**Proposed change to stairs of currently consented scheme to protect existing historical roof**

Proposed Change FF2 and 3 to Dressing room

## MAIN HOUSE - SECOND FLOOR

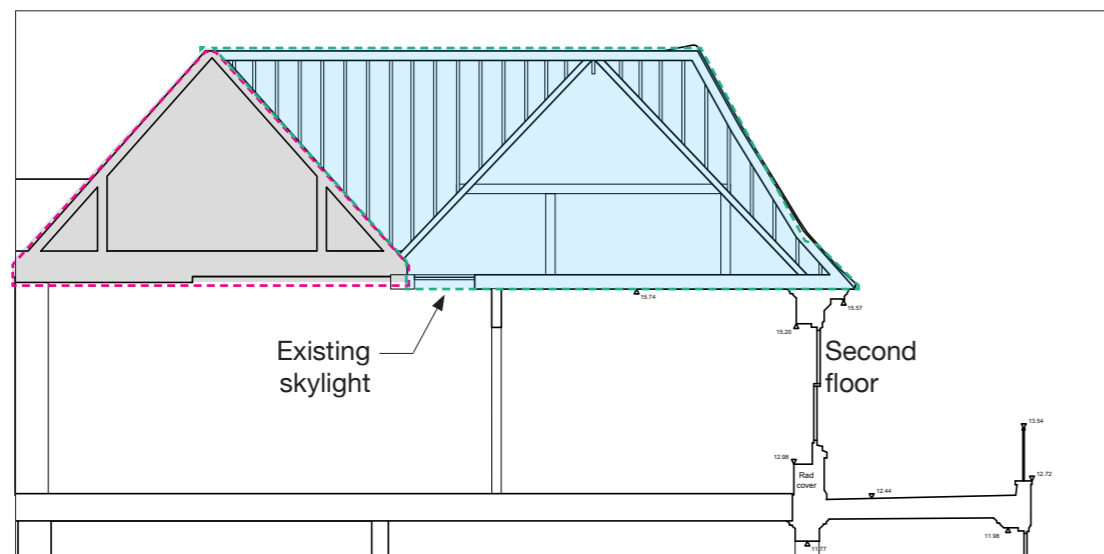
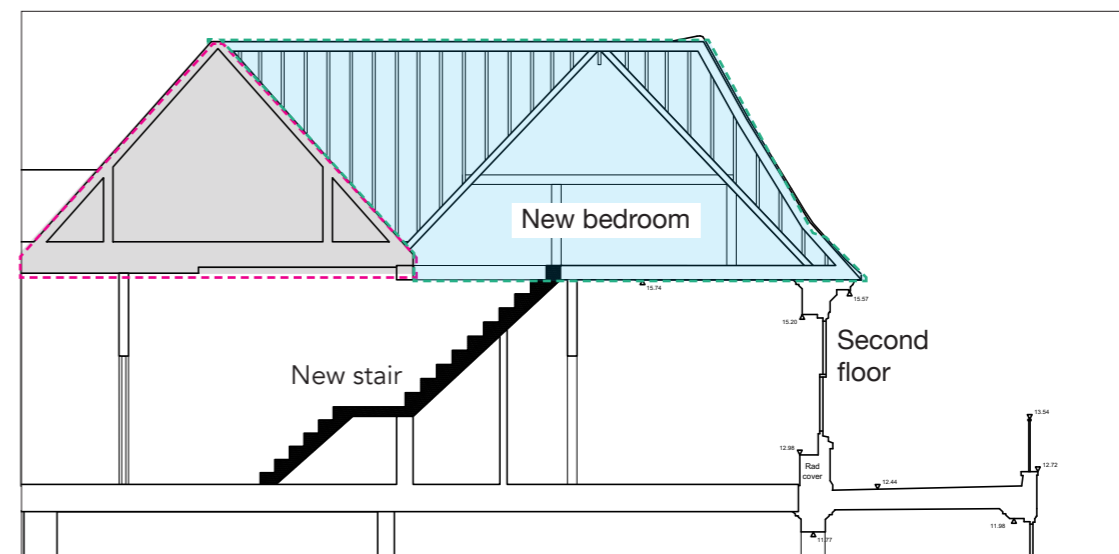
The staircase intervention has been carefully designed not to alter the 18th century roof structure. The interventions will be limited to the south of the building inside the Edwardian roof extension.

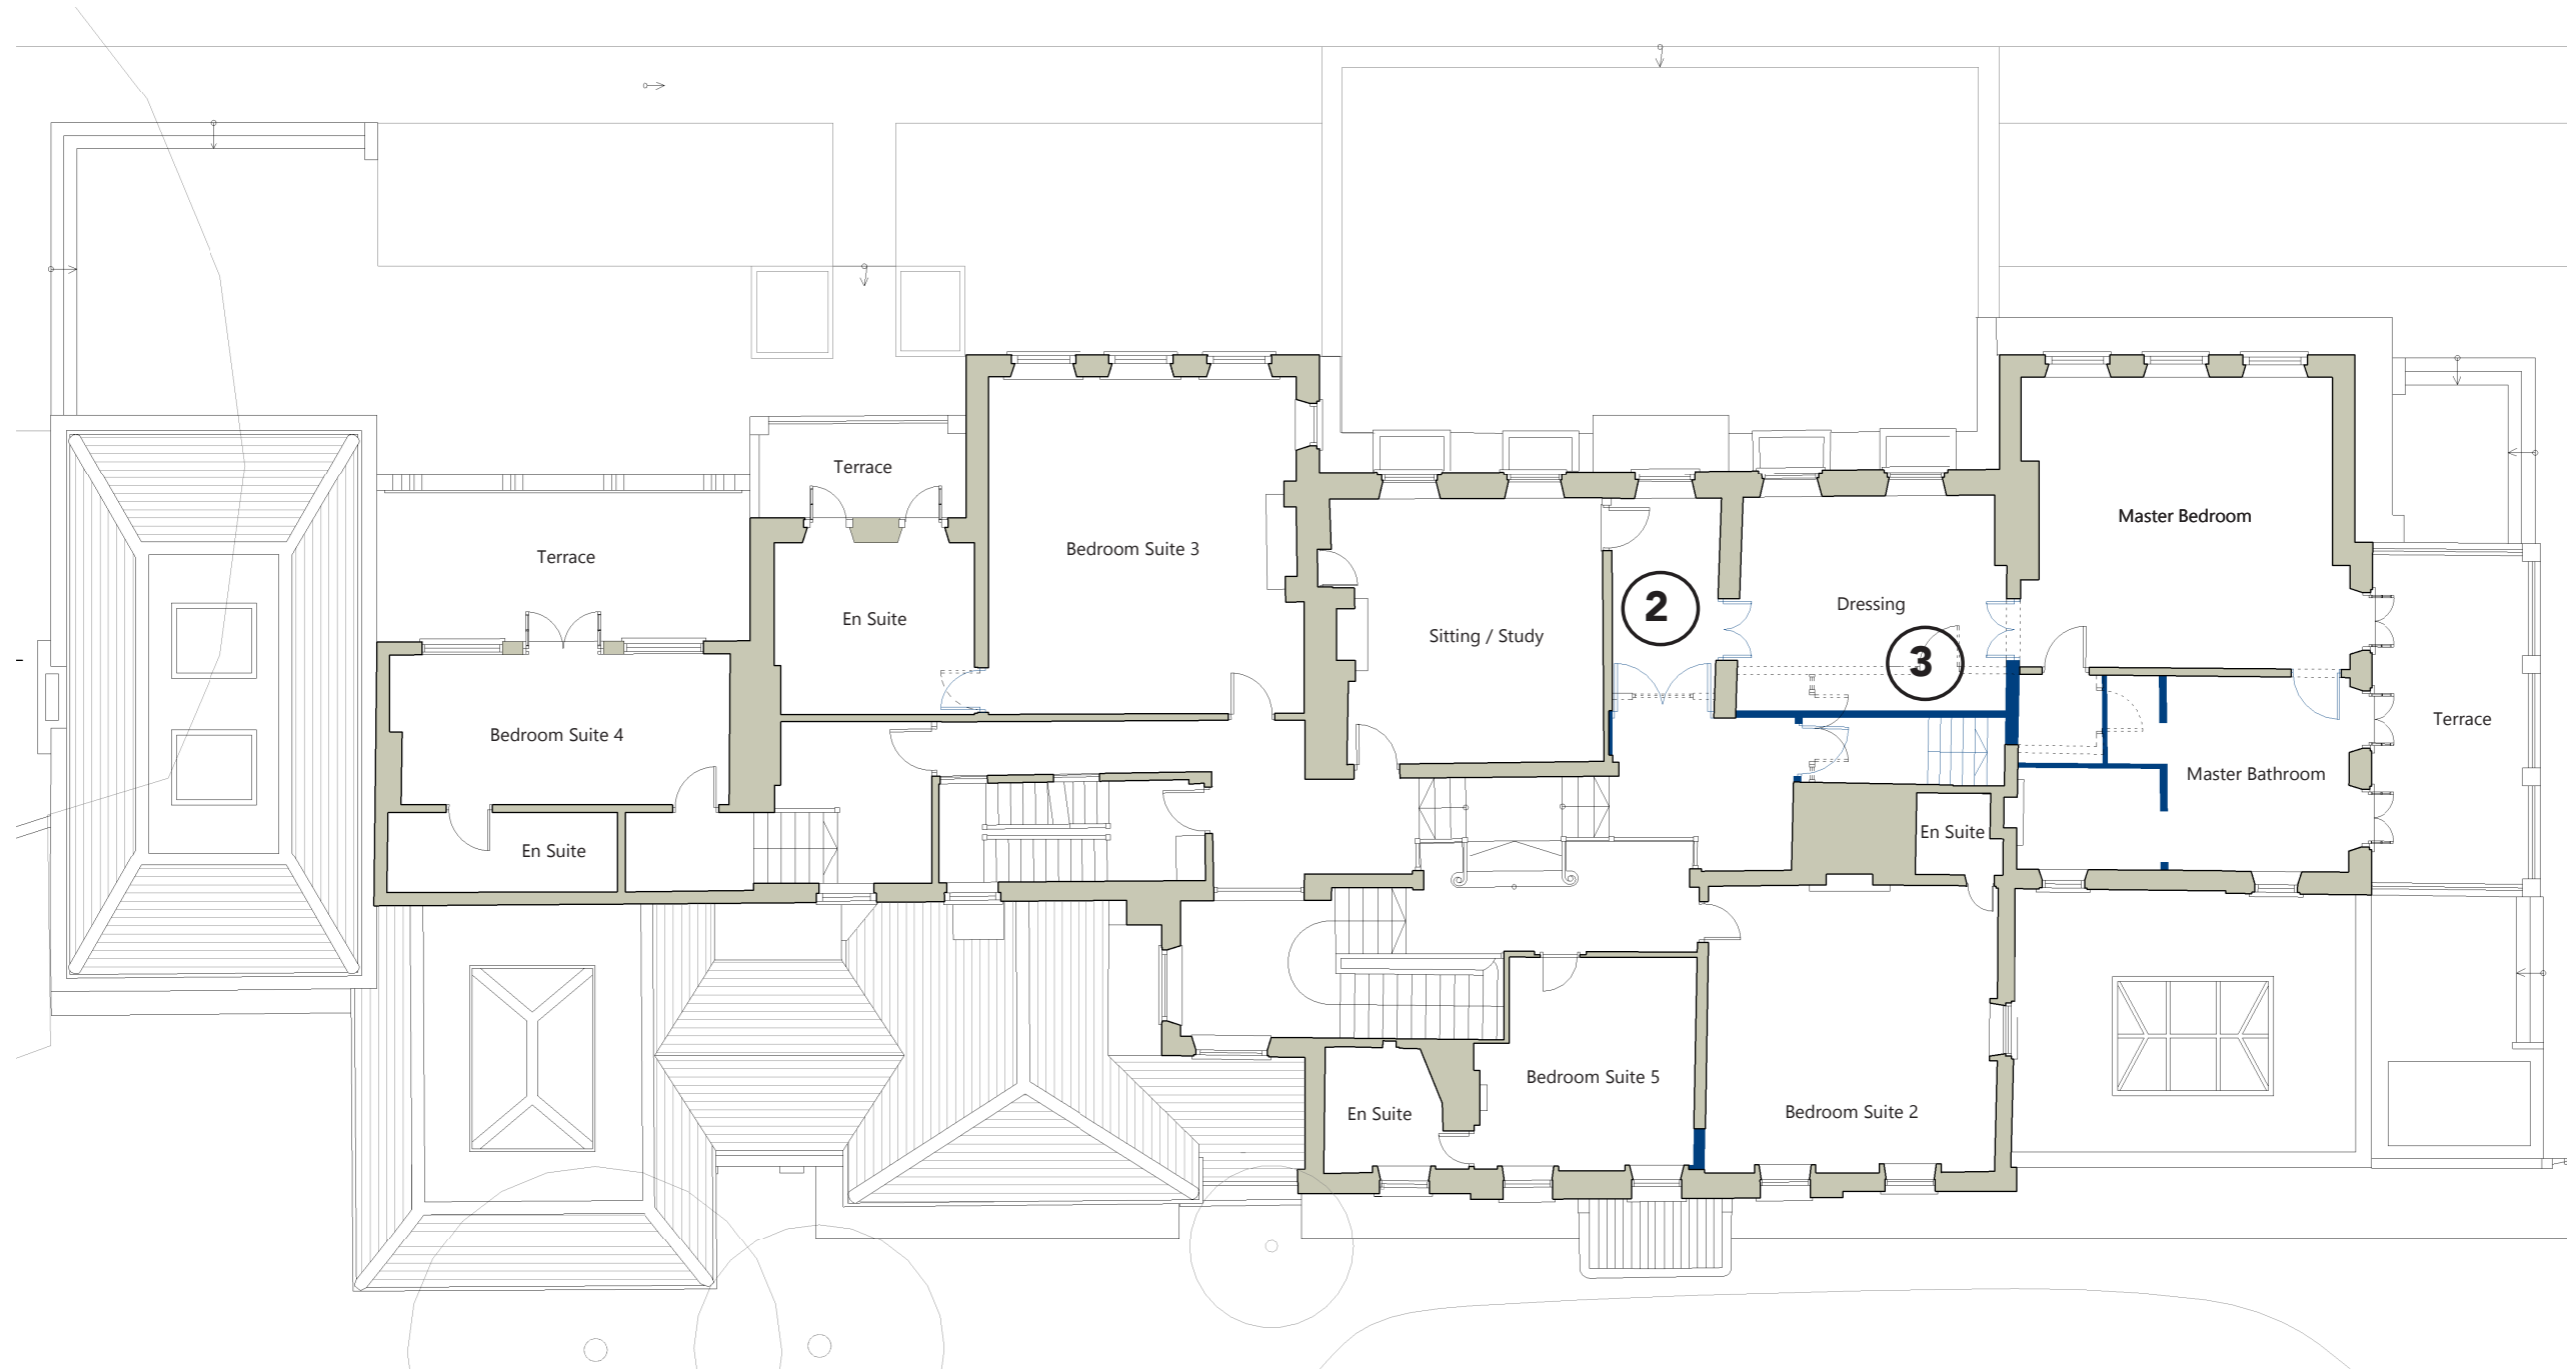
FF2. Relocated door to master suite entrance to avoid weakening junction with external wall

FF3. Approved new partition moved west to closer reflect original room proportion

Proposed change to consented scheme (in blue revised elements, in dotted previously consented)

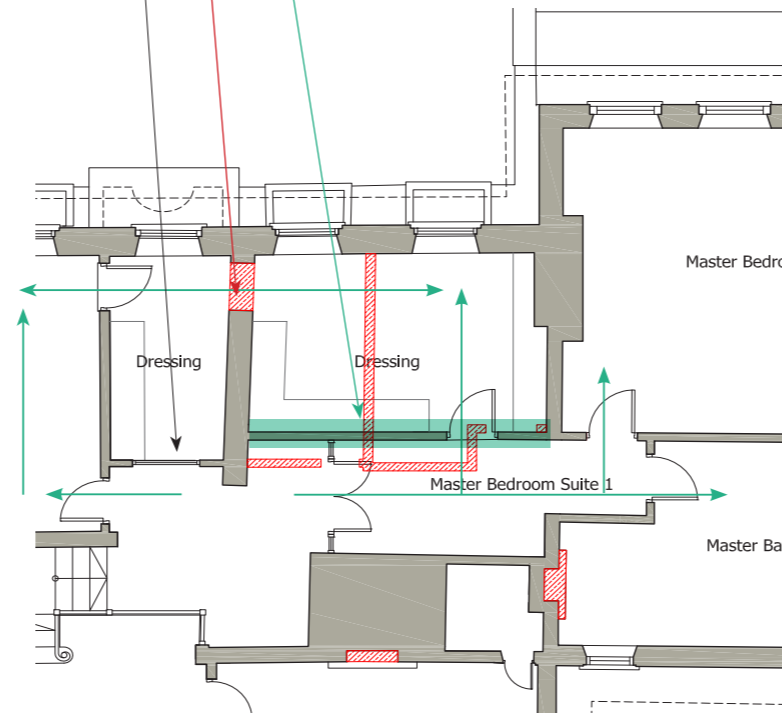
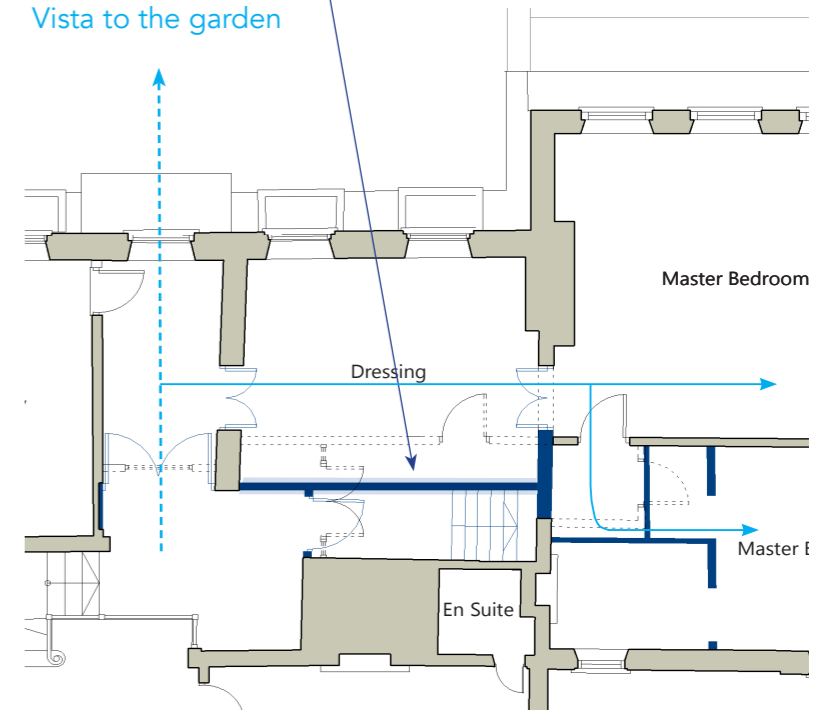
Consented opening weakens external elevation

Proposed new location reflects original room proportion

The new layout opens up the vista to the garden from the main hallway, establishes an appropriate hierarchical succession to the master suite, and improves the proportions of the dressing room to reflect original room proportion (as on the ground floor).

**Proposed change to consented scheme**  
 (in blue revised elements, in dotted previously consented)

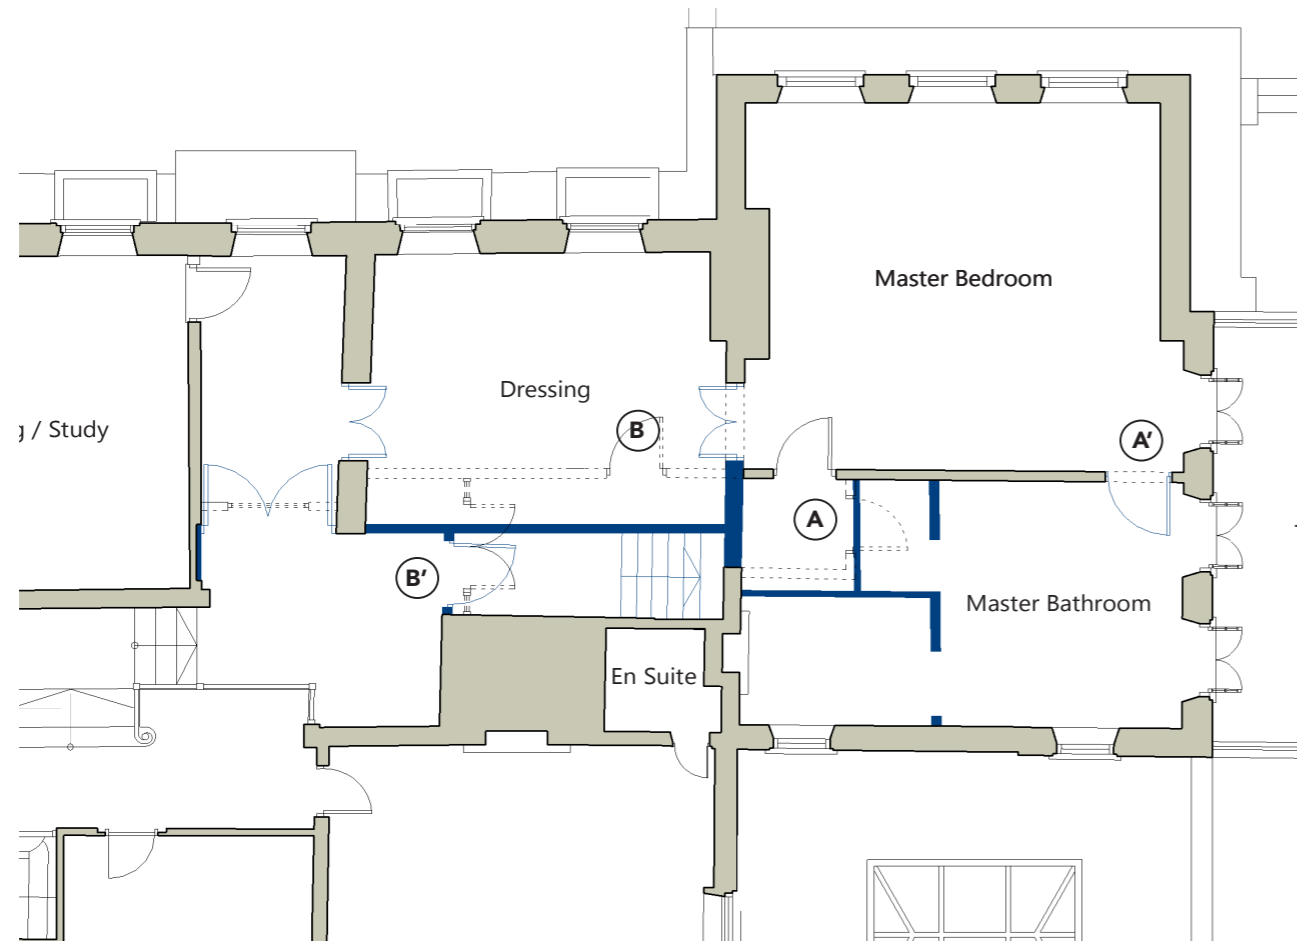
Structurally, the door to the dressing is moved away from the external wall to avoid weakening the junction with the external wall and its de-lamination.

Removed doors (A and B) are to be reused in locations A' and B'

**Typical retained doors**

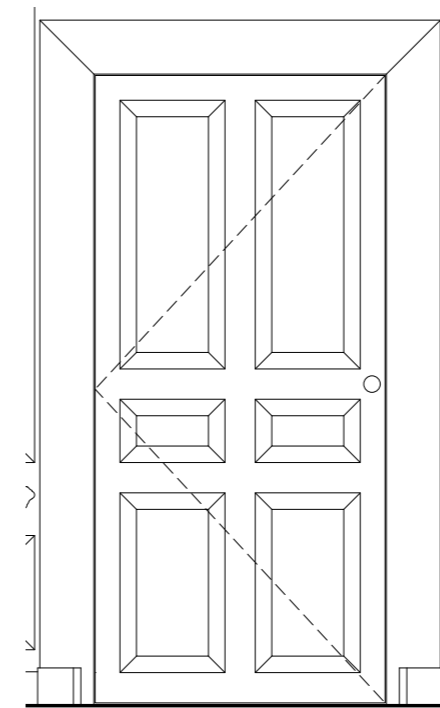
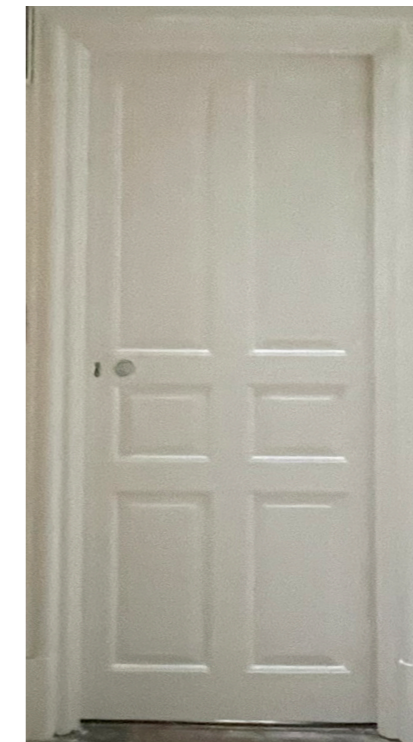
Existing six panel doors to be retained through out and reused. All new doors to match existing six panelled doors in layout and detail

# MAIN HOUSE SECOND FLOOR

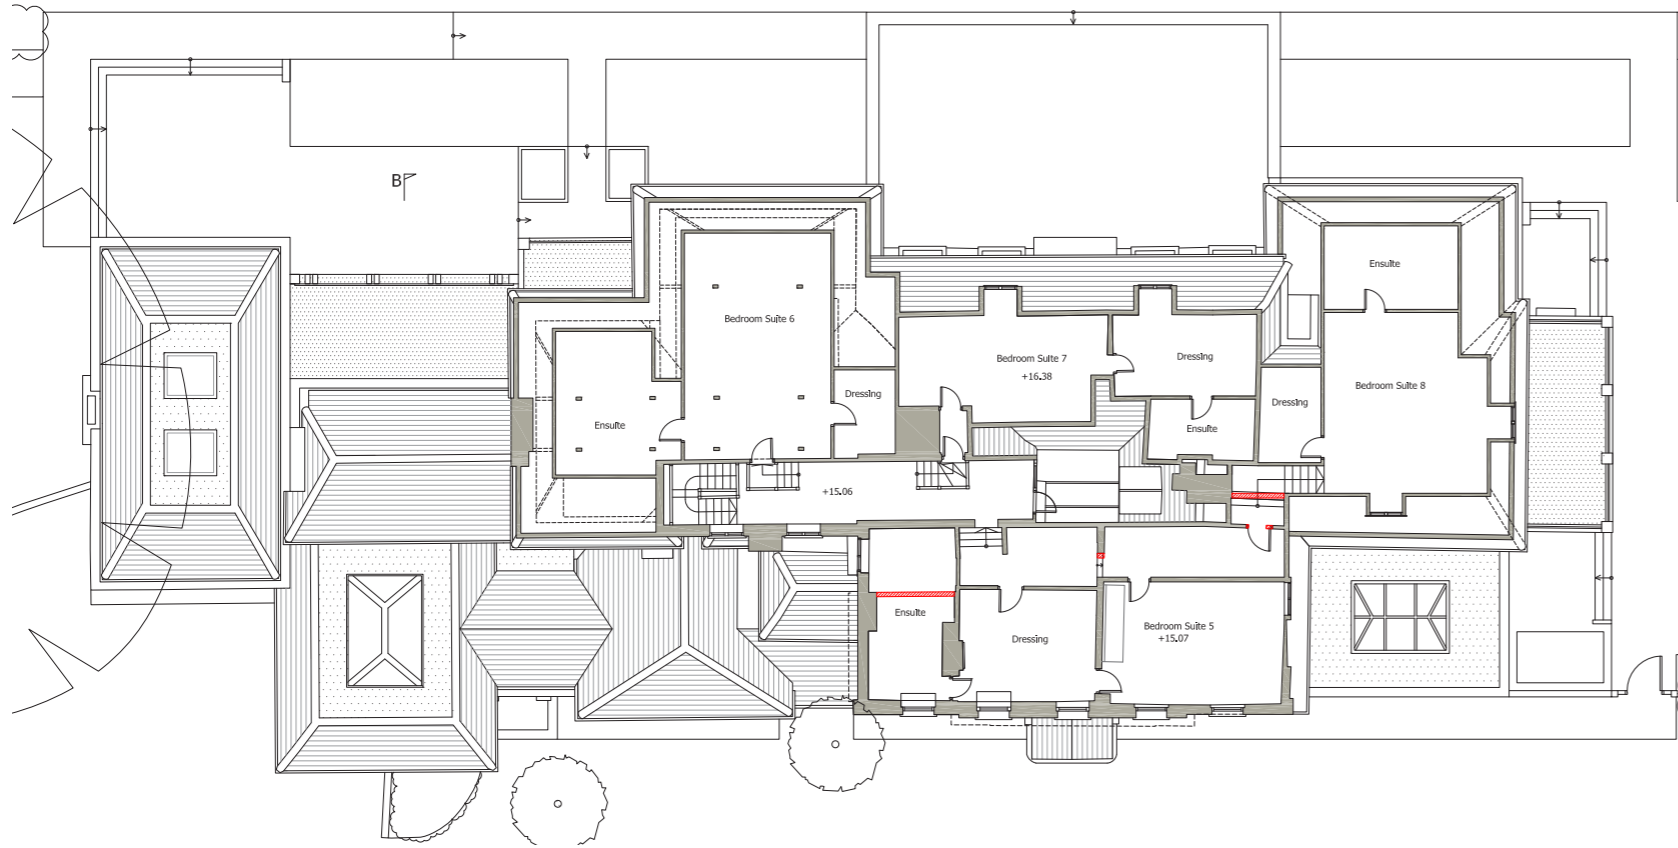
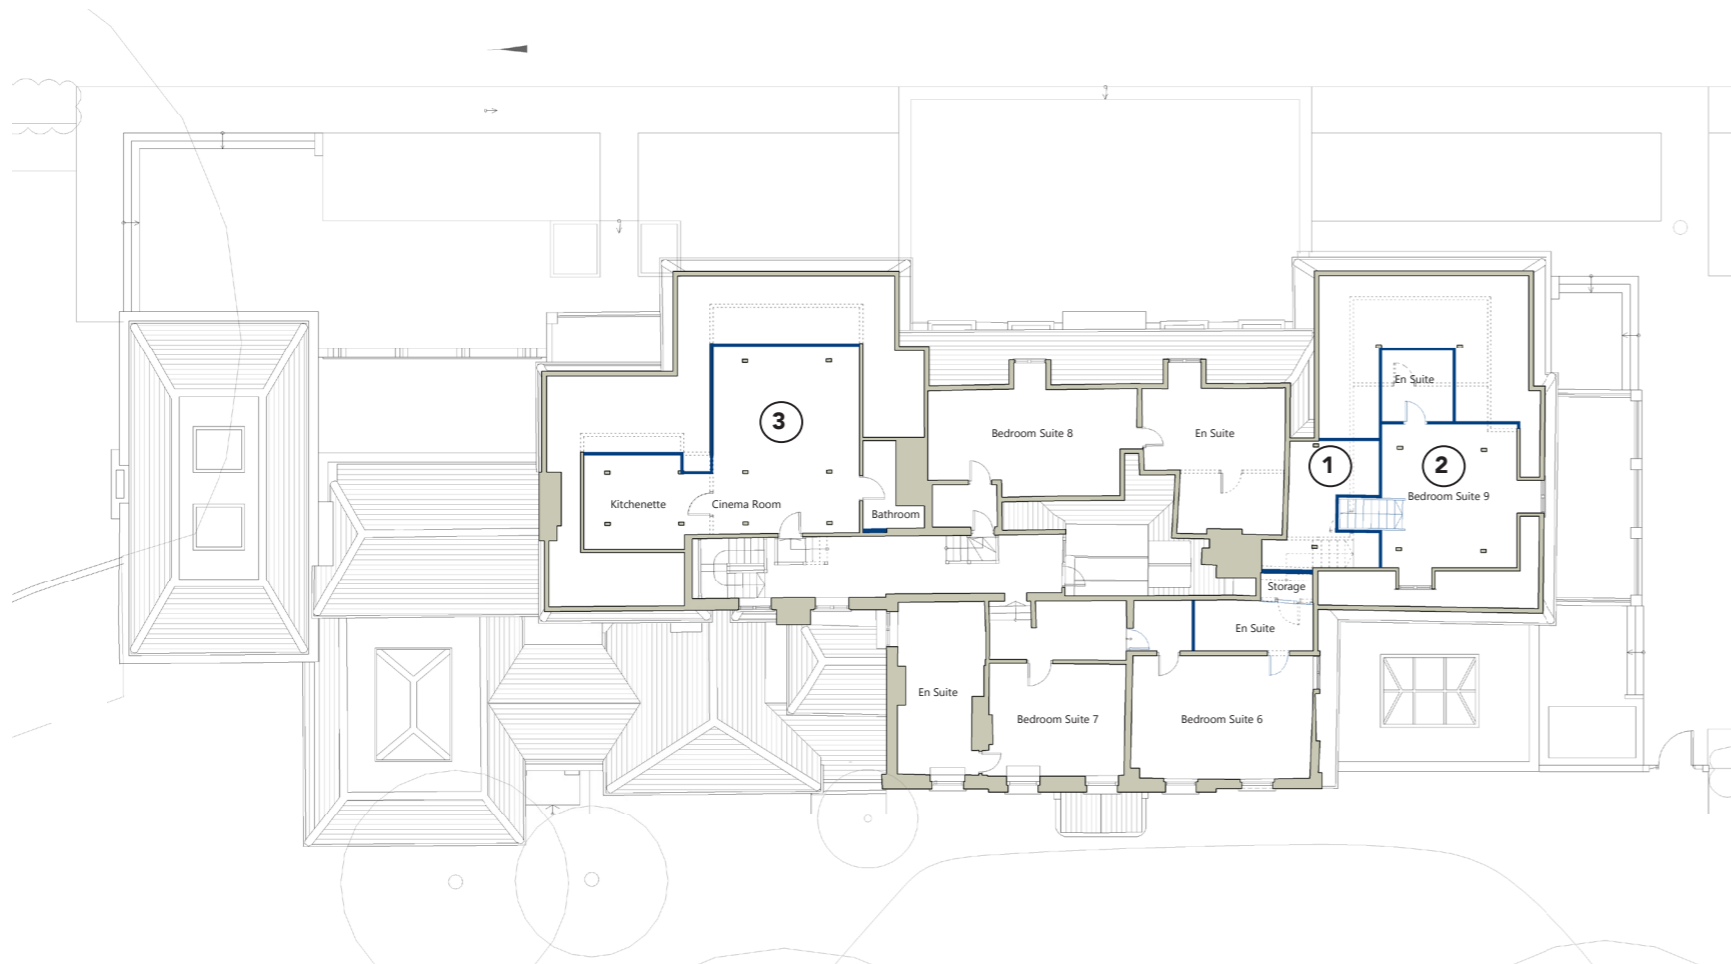
- SF1. Introduce new stair to access attic bedroom. See change FF1 for details.
- SF2. New layout to attic bedroom to reduce footprint in light of existing roof structure and head height.
- SF3. Bedroom 6 and En-suite in the consented scheme is proposed to be made into family/cinema room due to the lack of dormer windows and footprint reduced in light of existing roof structure and head height.
